Lee County, Florida
DEPARTMENT OF COMMUNITY DEVELOPMENT
ZONING SECTION
STAFF REPORT

CASE NUMBER: DCI2023-00050
CASE NAME: DIPLOMAT HOUSE F/K/A DIPLOMAT RPD AMENDMENT
TYPE OF CASE: MAJOR PLANNED DEVELOPMENT AMENDMENT
HEARING EXAMINER DATE: JUNE 26, 2024
SUFFICIENCY DATE: MAY 14, 2024

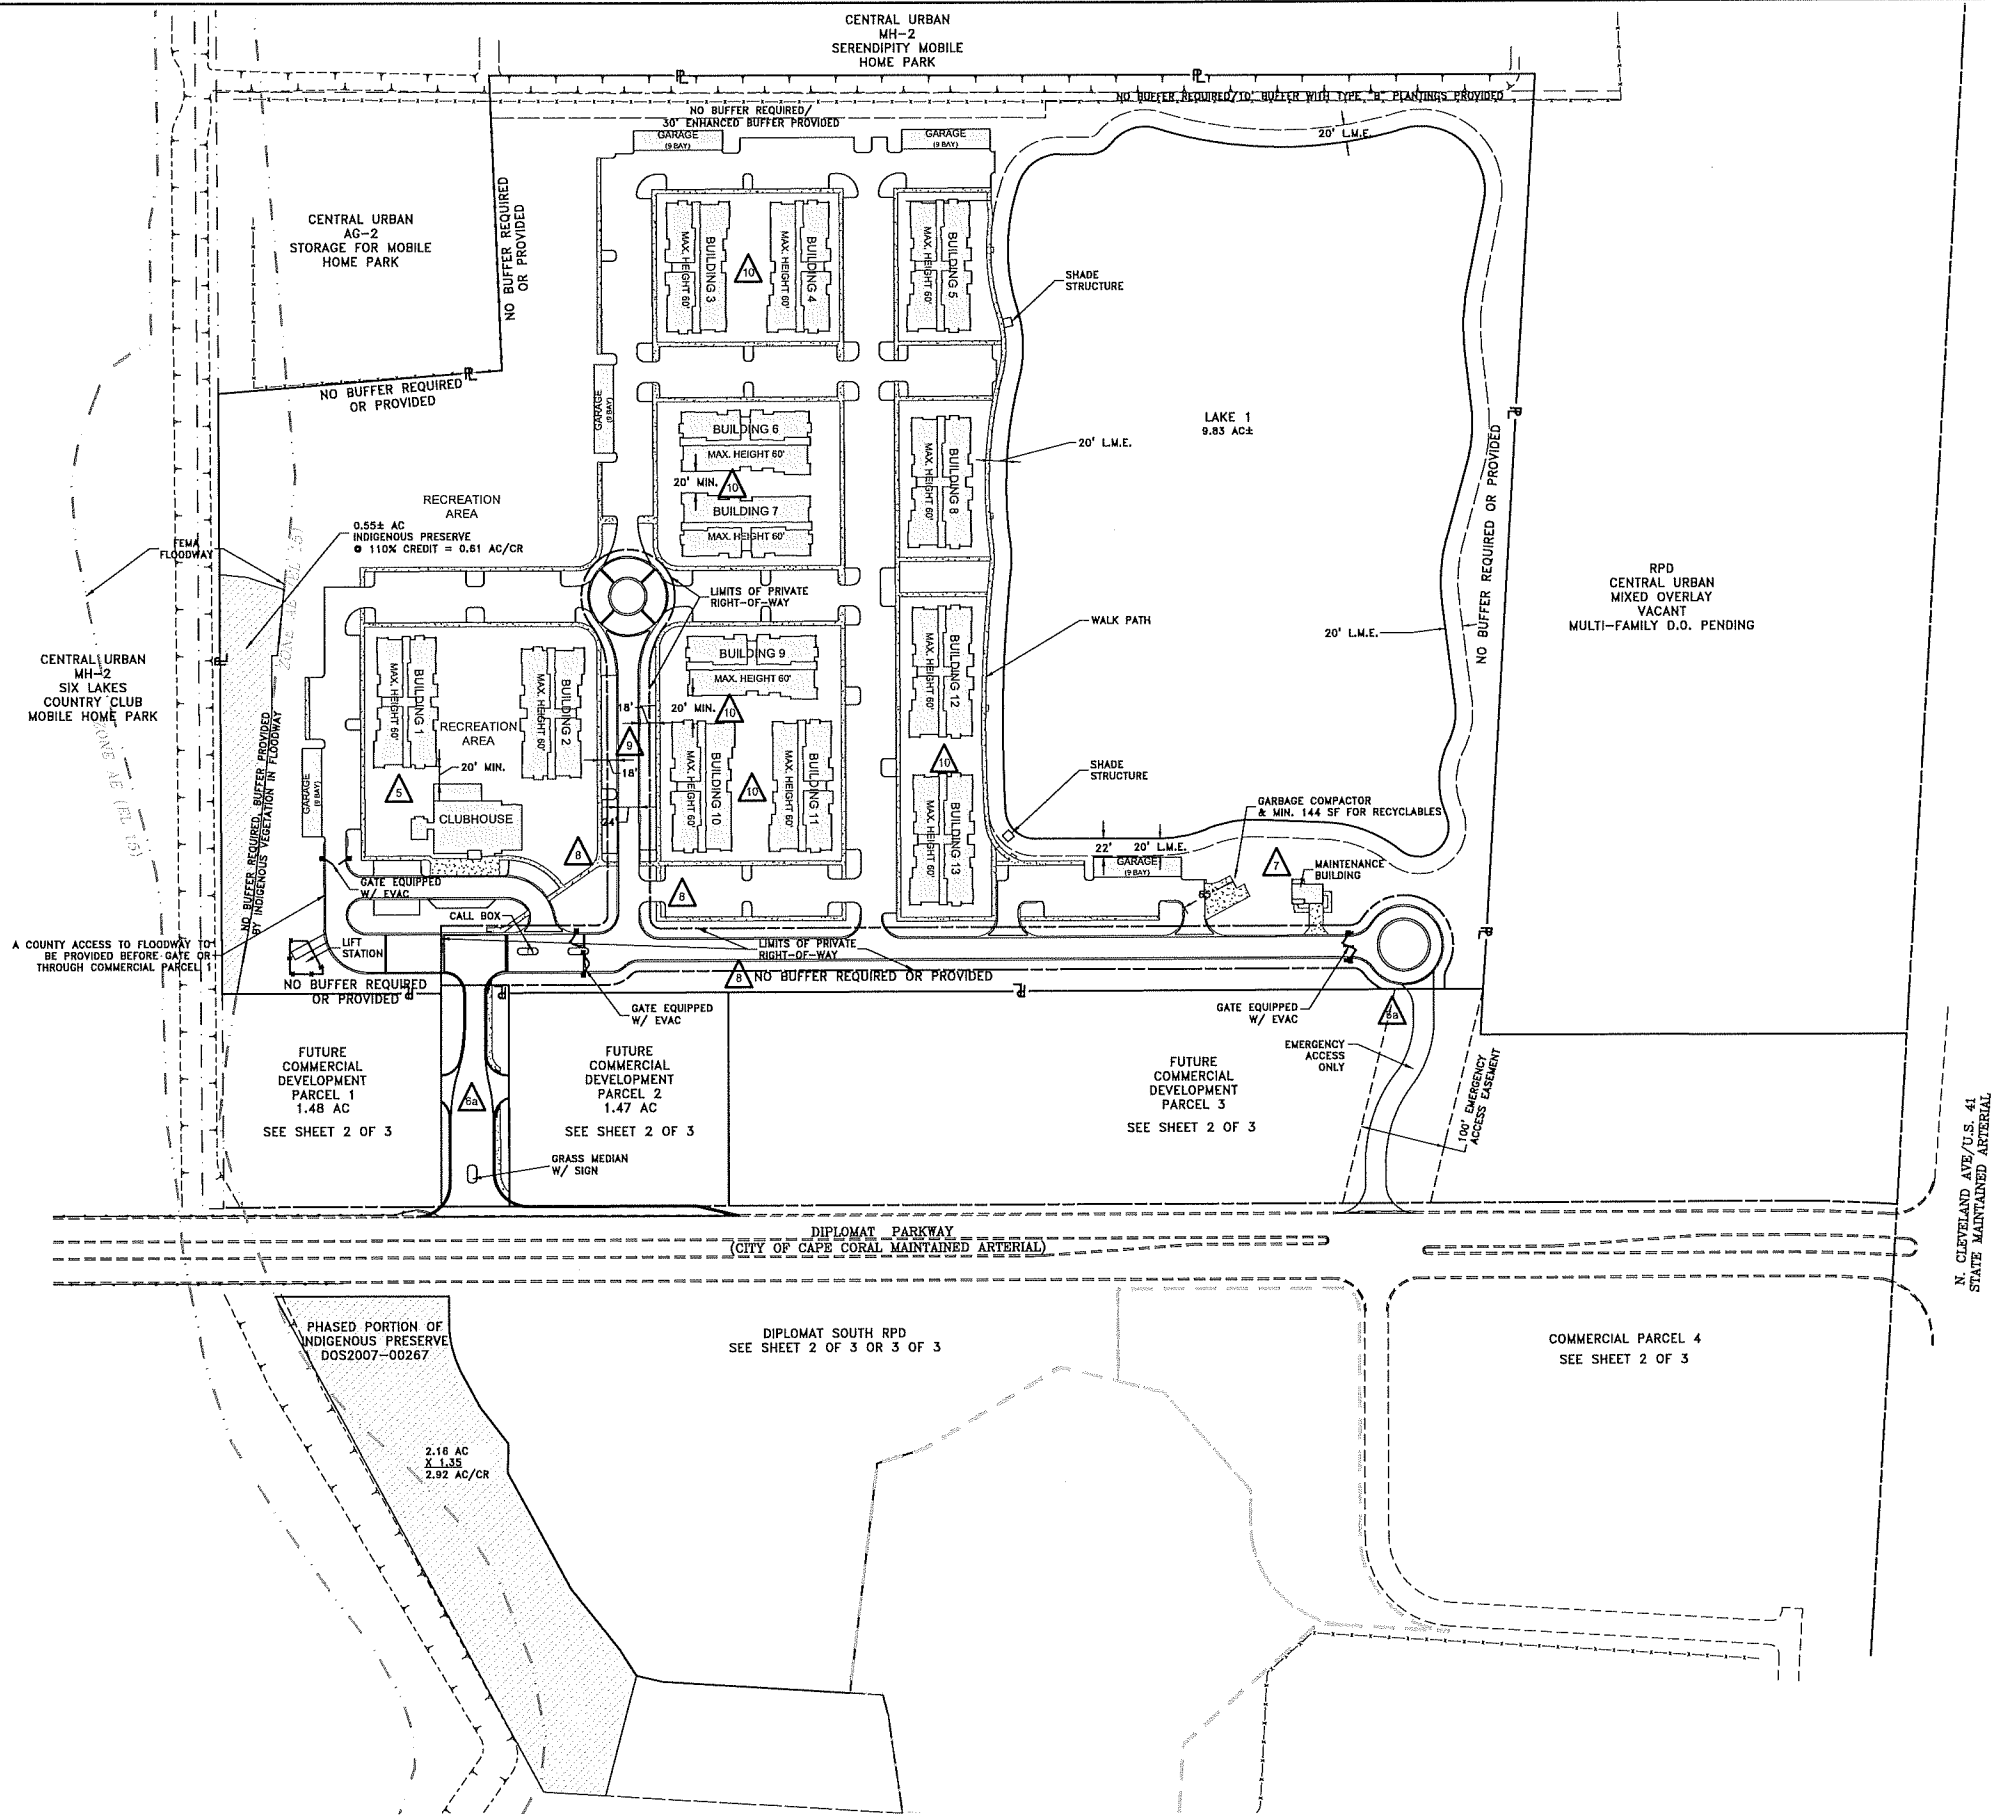
Request to amend this deviation to allow no buffers to internal rights-of-way for the North RPD.

8. **Certain internal buffers not required** - Deviation 8 [previously contained in Z-11-002 and subsequent approvals from LDC §10-416(d)(3)] seeks relief from the LDC §10-416(d)(3) 10-425(f)(1) requirement that a Type C/F for five-foot wide buffer along rights-of-way planted with five trees per 100 linear feet between the proposed RPD/CPD uses internal to the development, to allow no buffer between the RPD/CPD uses where the commercial uses are separated from the residential uses within the North RPD project to internal rights-of-way by a private road. This deviation is APPROVED.
